**PLEASANT PRAIRIE PLAN COMMISSION MEETING
VILLAGE HALL AUDITORIUM
9915 39th AVENUE
PLEASANT PRAIRIE, WISCONSIN
6:00 P.M.
JANUARY 14, 2013**

- C. Consider the request of Paul Schmitter, agent on behalf of CenterPoint WisPark Land Company, LLC owner of the vacant property north of 109th Street between 80th and 88th Avenues for **Preliminary Site and Operational Plans** for mass grading for the proposed 471,403 square foot industrial building to be known as LakeView XIV.

- E. Consider the request of Florin Stanescu of Meijer Distribution, Inc., applicant for of the property located at 7400 95th Street for **Preliminary Site and Operational Plans** for mass grading and early footings and foundations for the construction of a 253,677 square foot distribution building for Meijer Distribution, Inc.

JOB NUMBER 213016	SHEET NUMBER C-105
----------------------	-----------------------

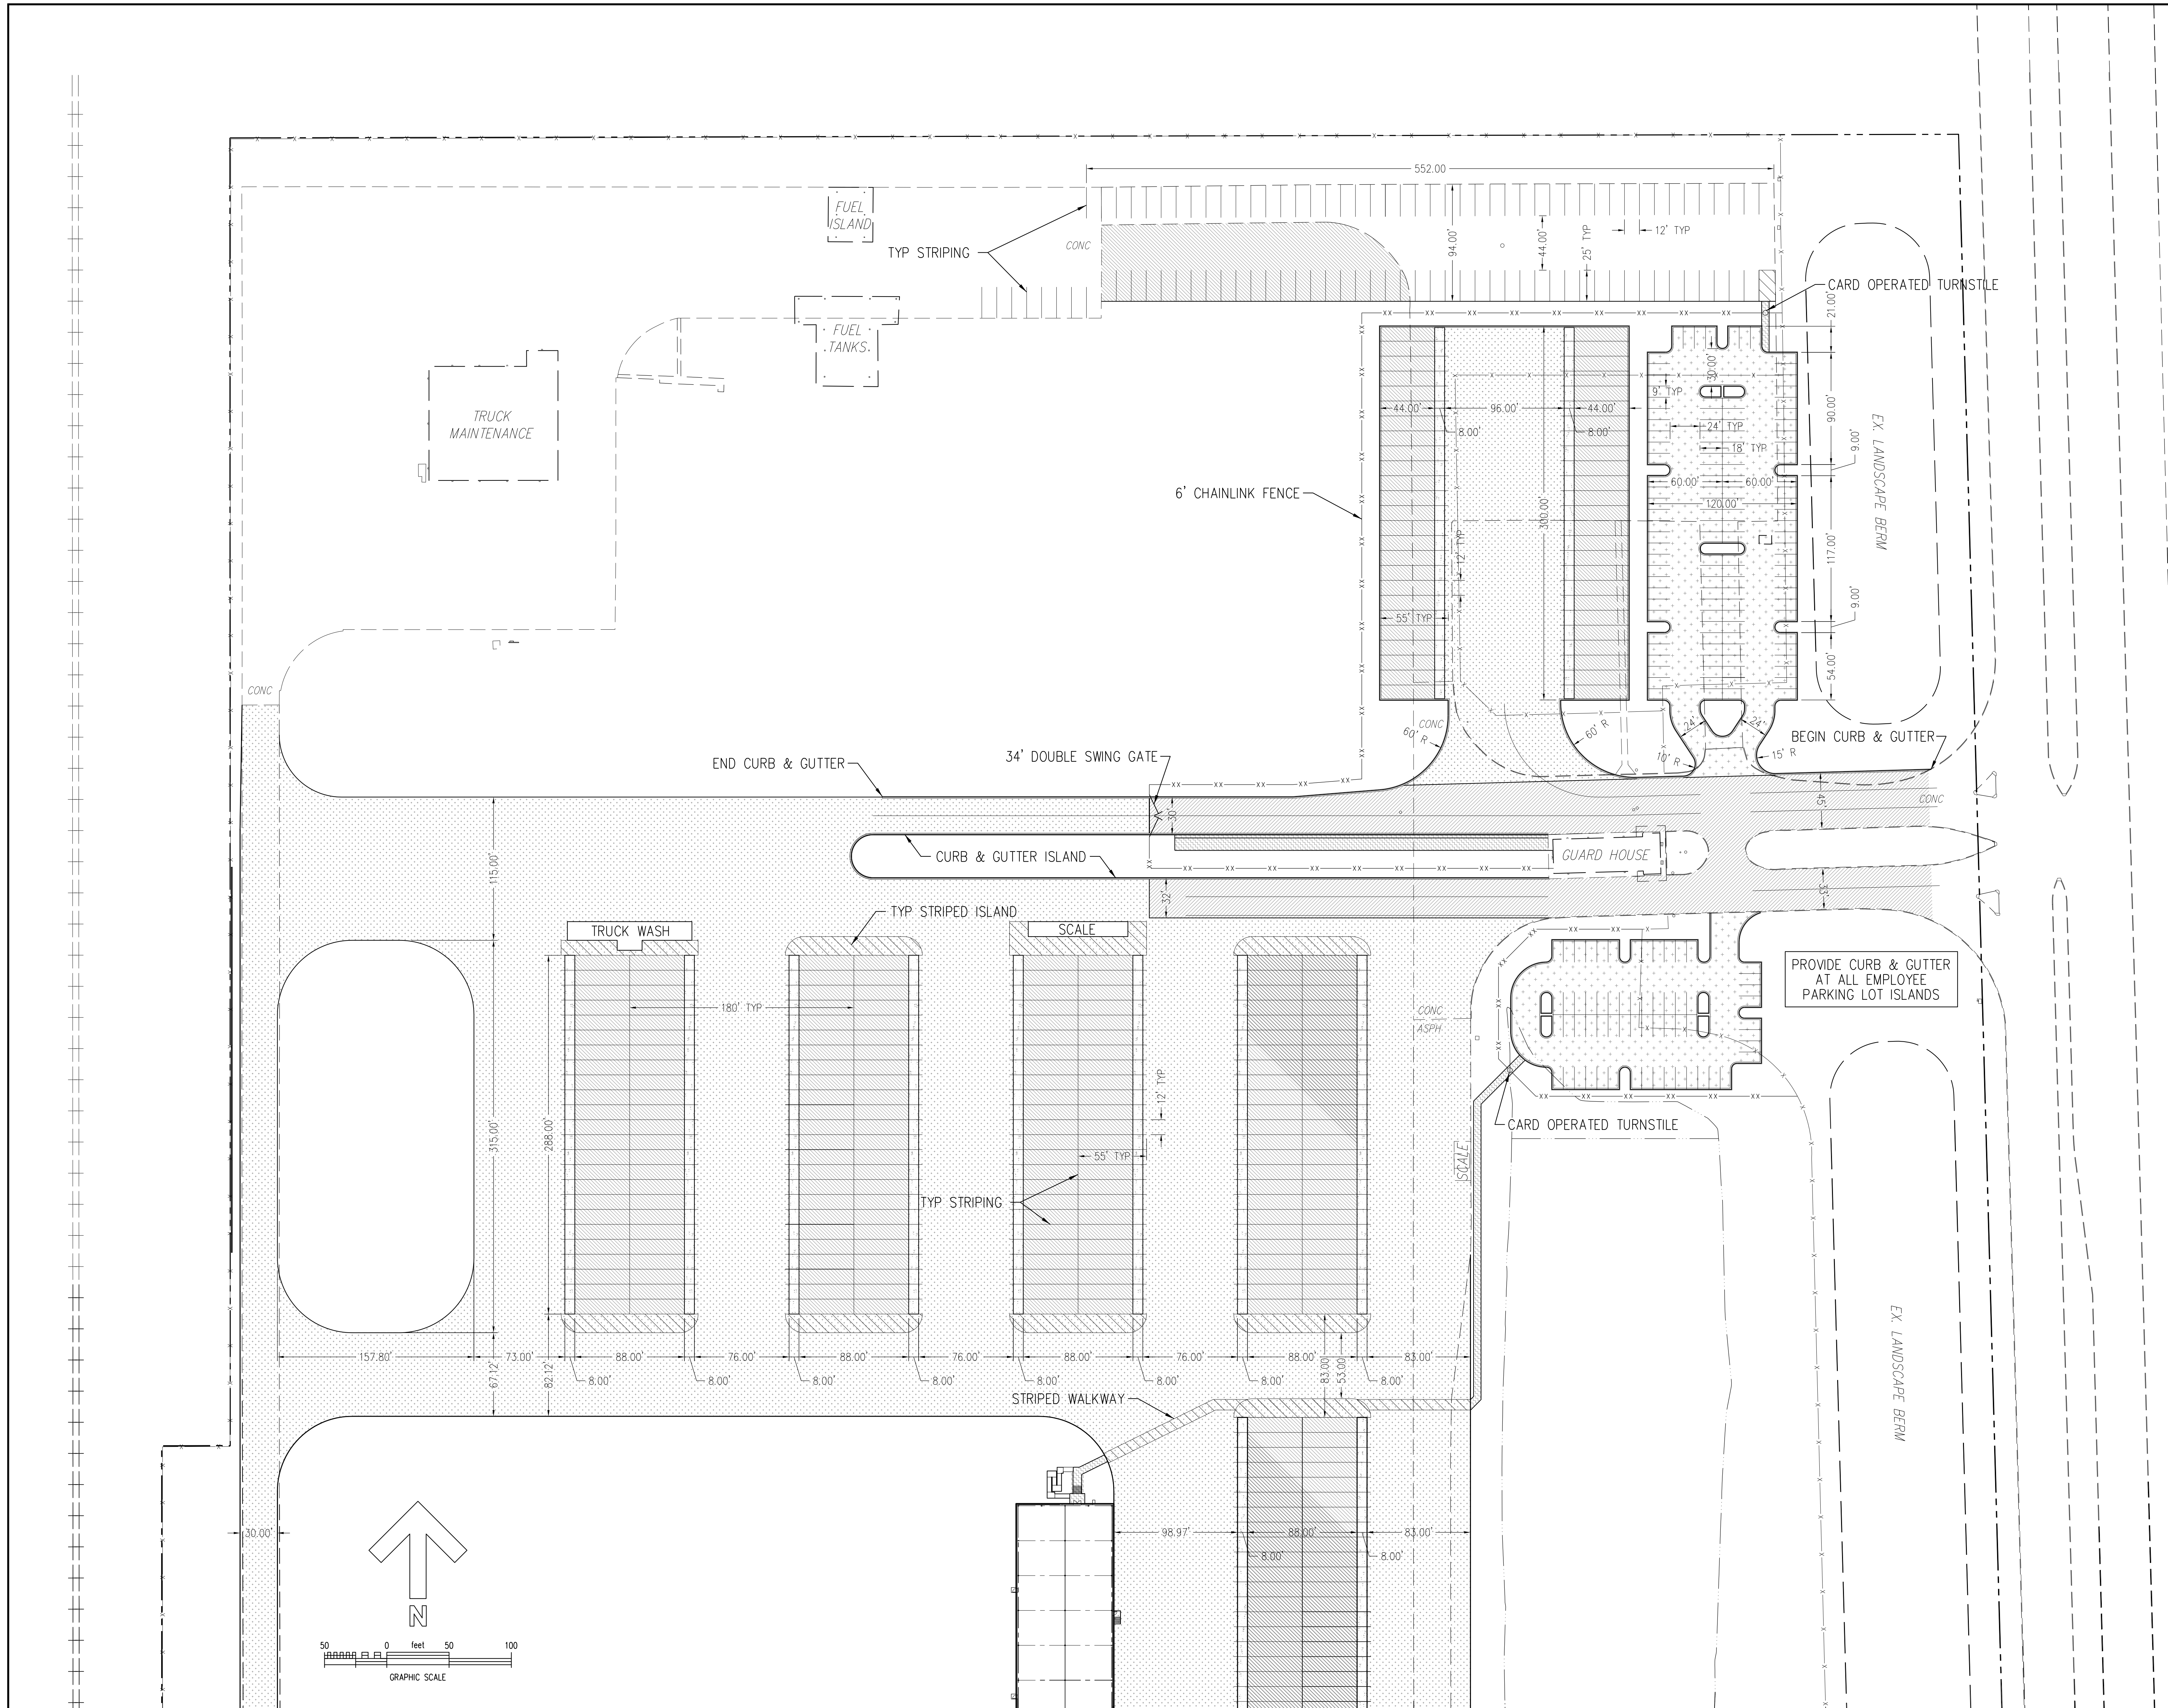
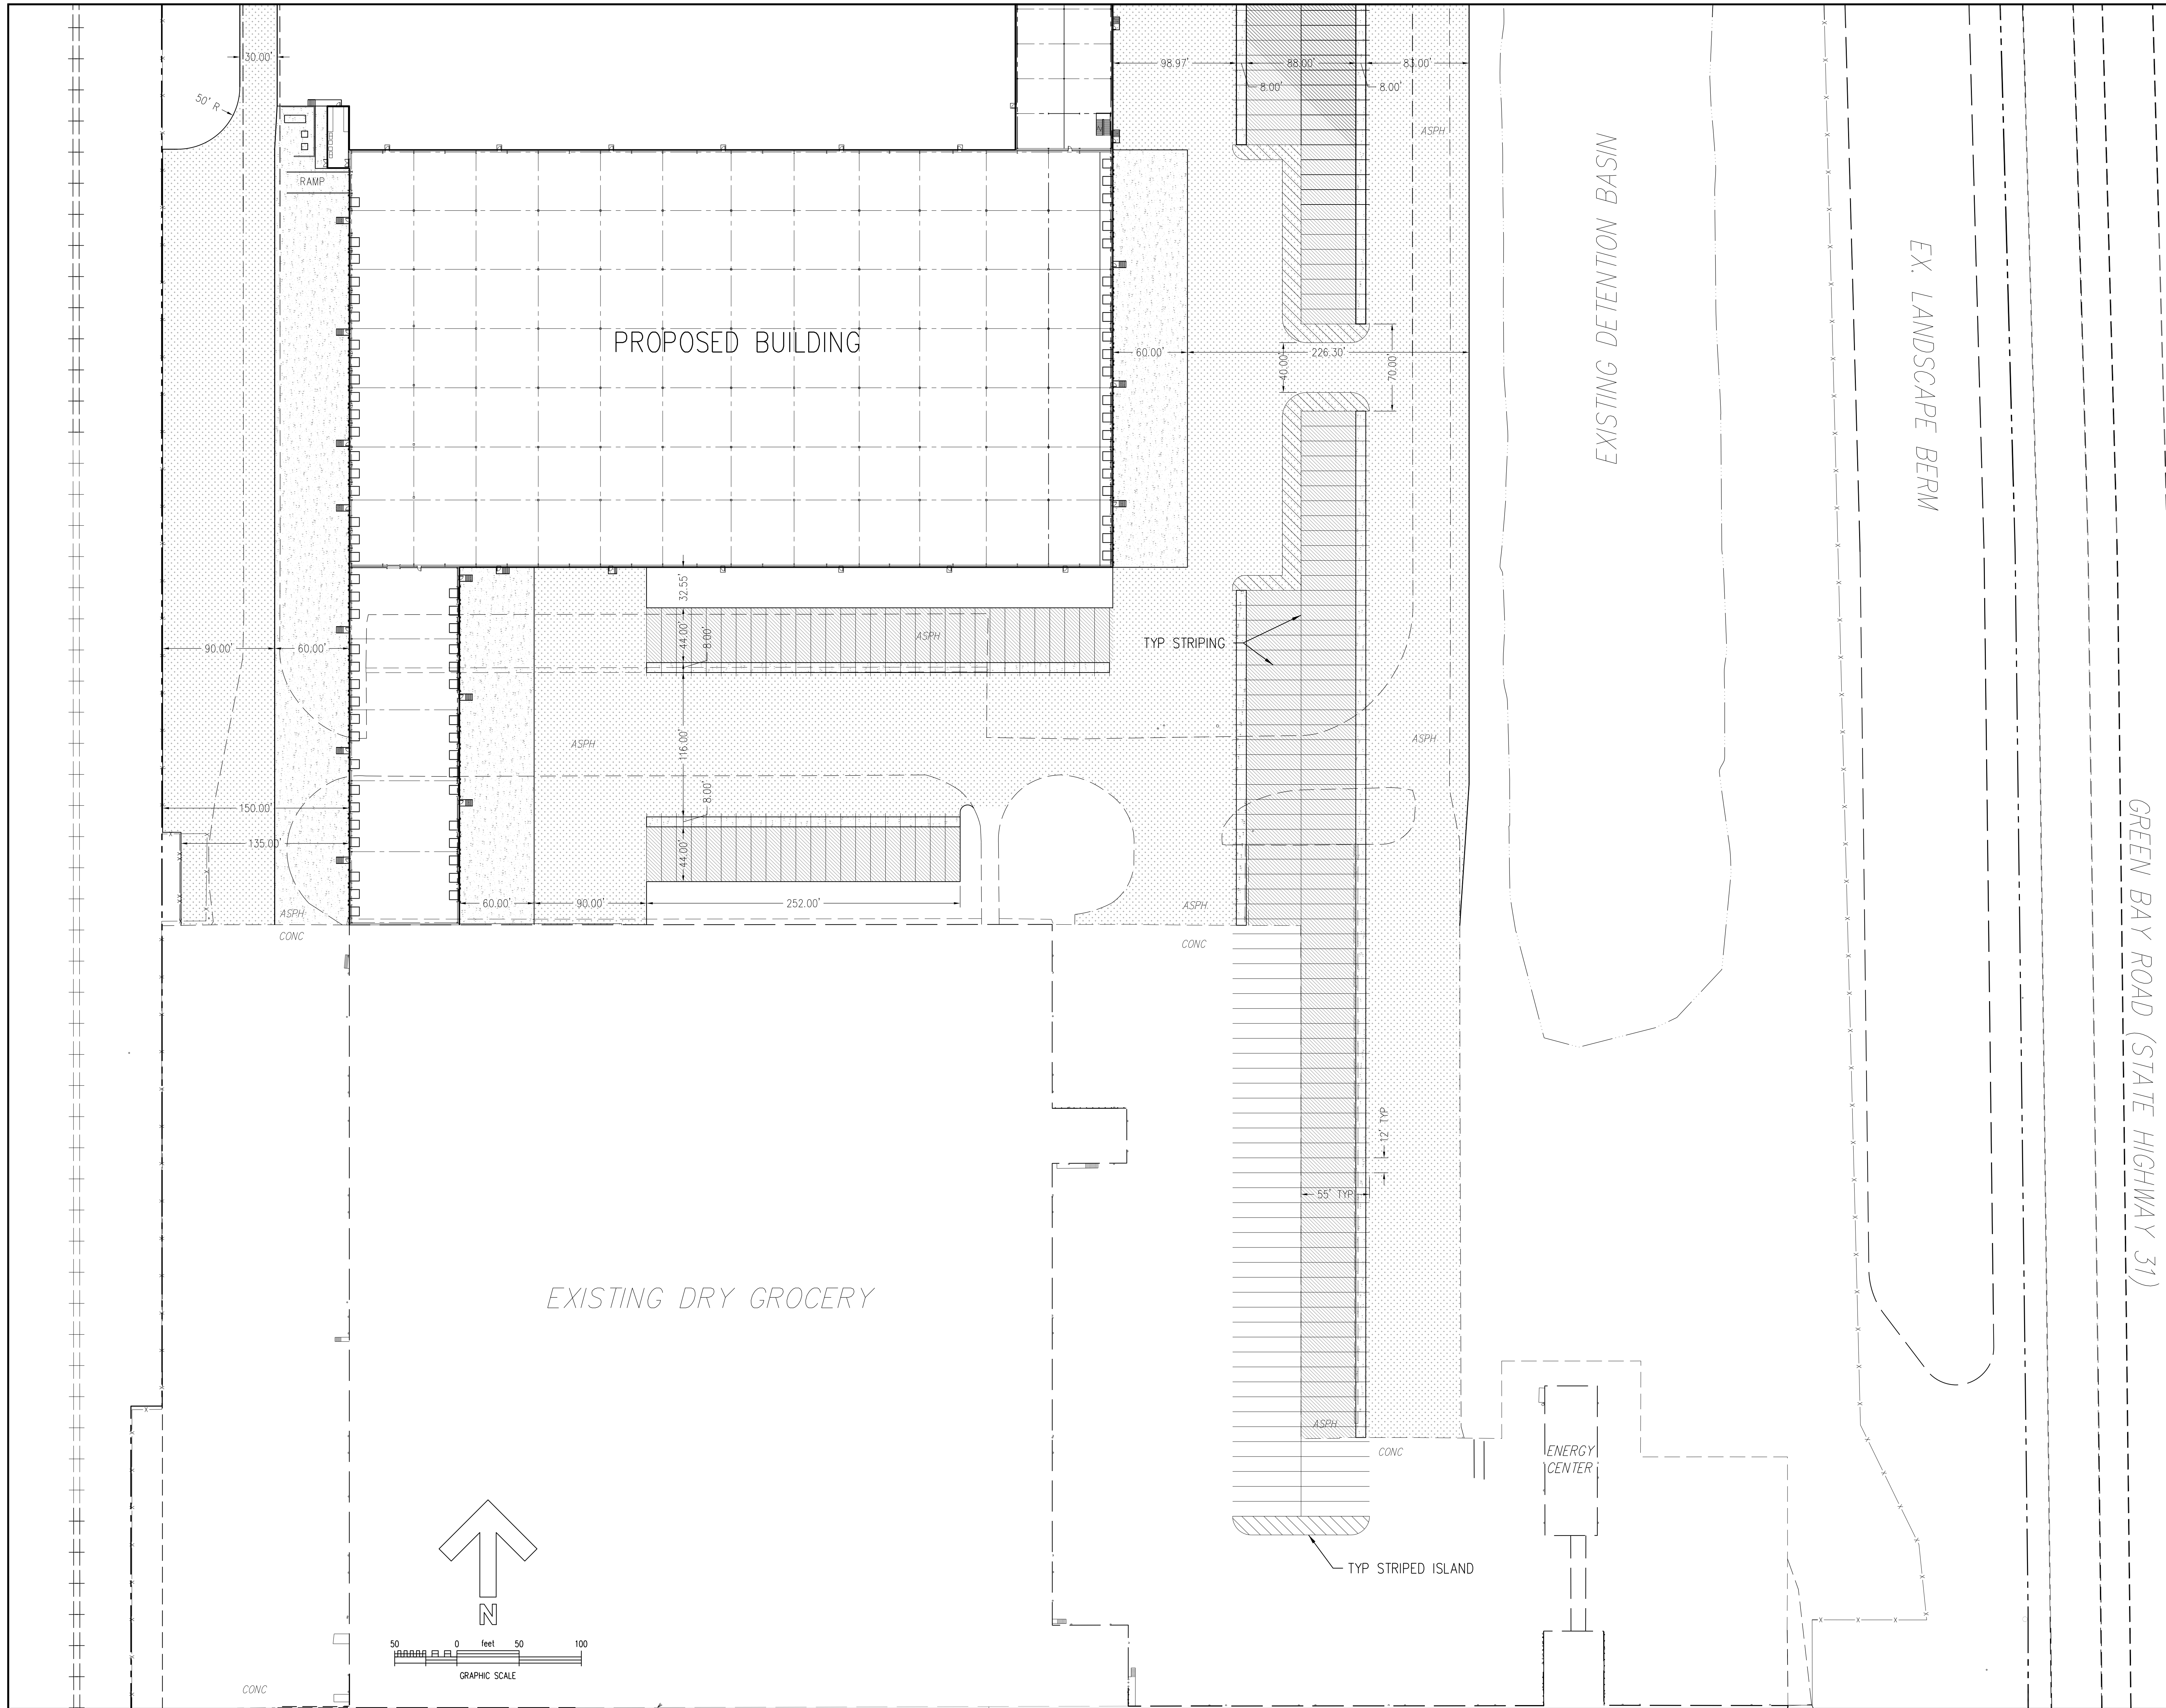
- p. On Sheets C-105 & C-106 (Site Layout Plans):
- i. Label the following: Green Bay Road (STH 31) on sheet C-106, sidewalk by the pond, Union Pacific Railroad, property line(s), existing fence (material and height).

11 CHAIN LINK FENCE
C-500 N.T.S.

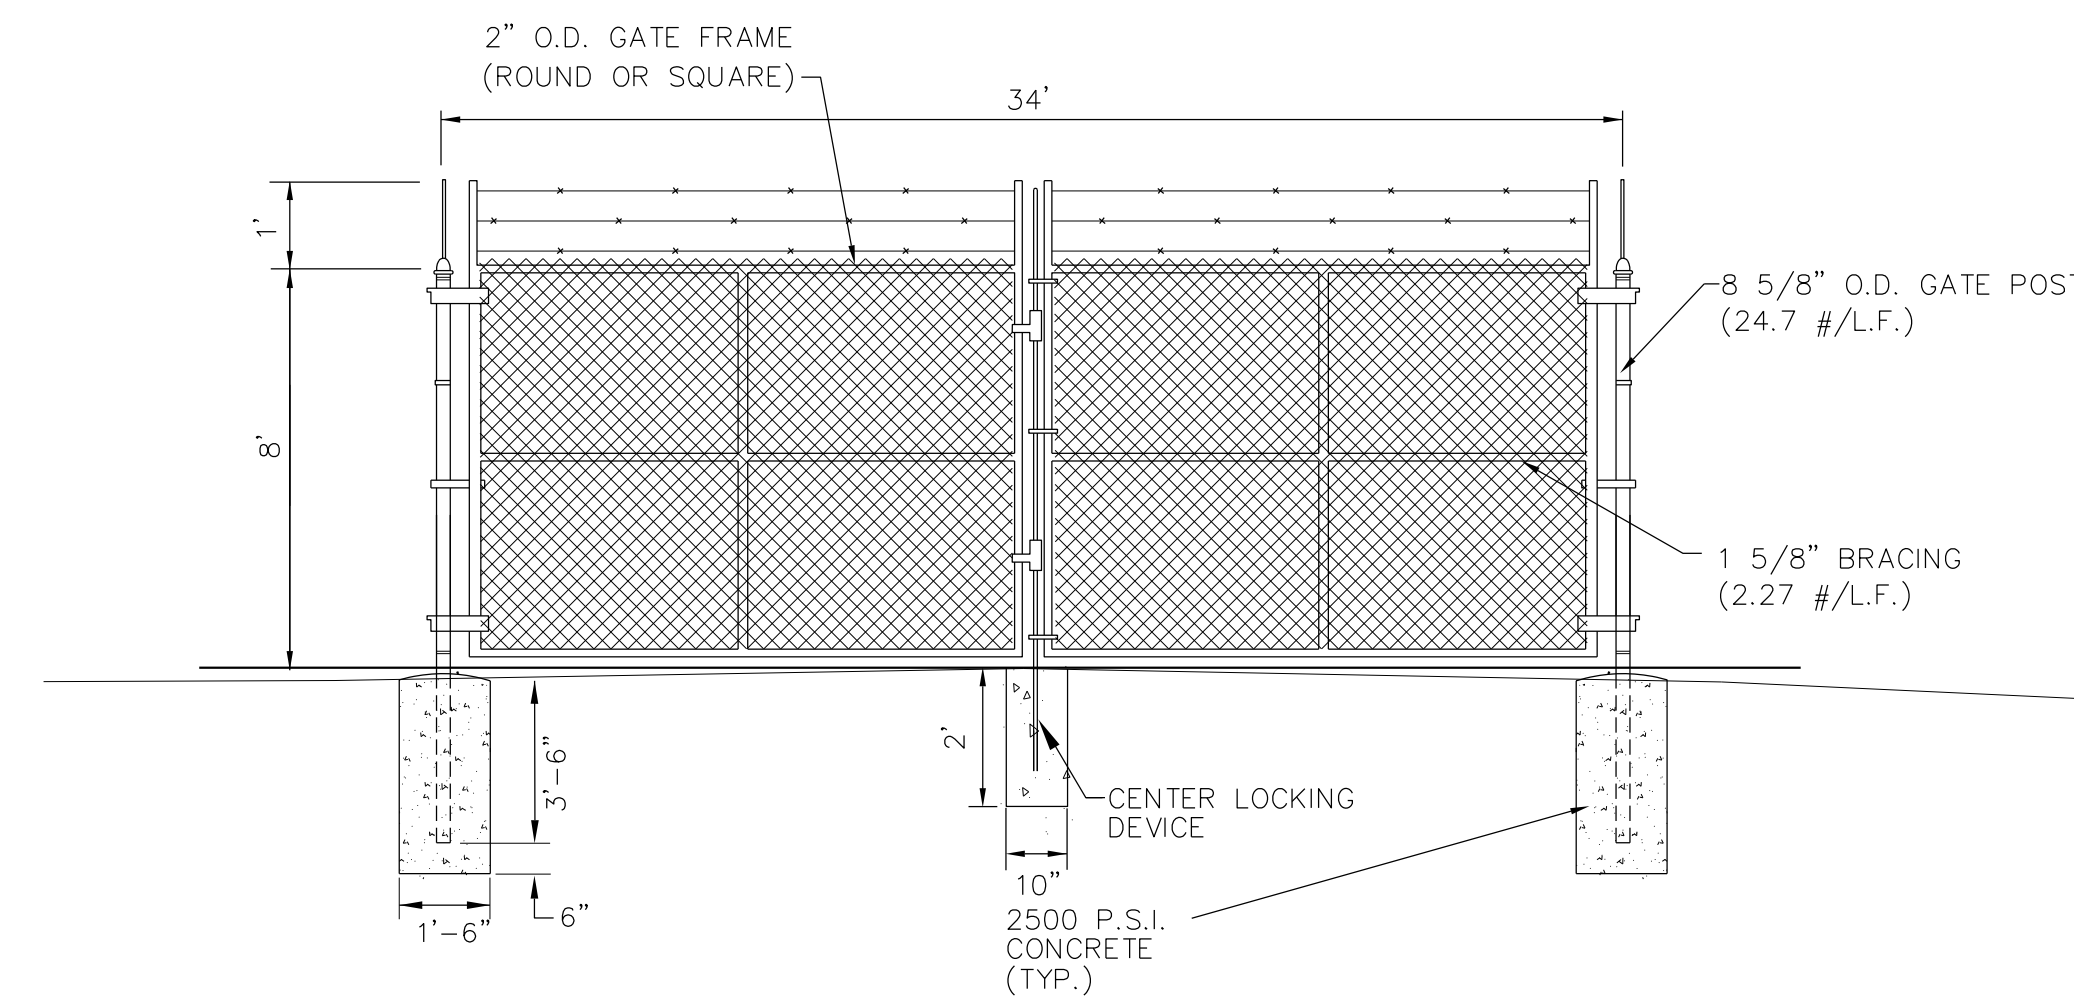
- q. Remove the "Fergusson Drive" label from all applicable plan sheets. 95th Street is no longer referred to as "Fergusson Drive".
- r. On Sheet C-500, note that the chain-link fencing shall be vinyl-coated (black, or other color as approved by the Zoning Administrator). In addition remove the three (3) strings or barbwire above the fence.
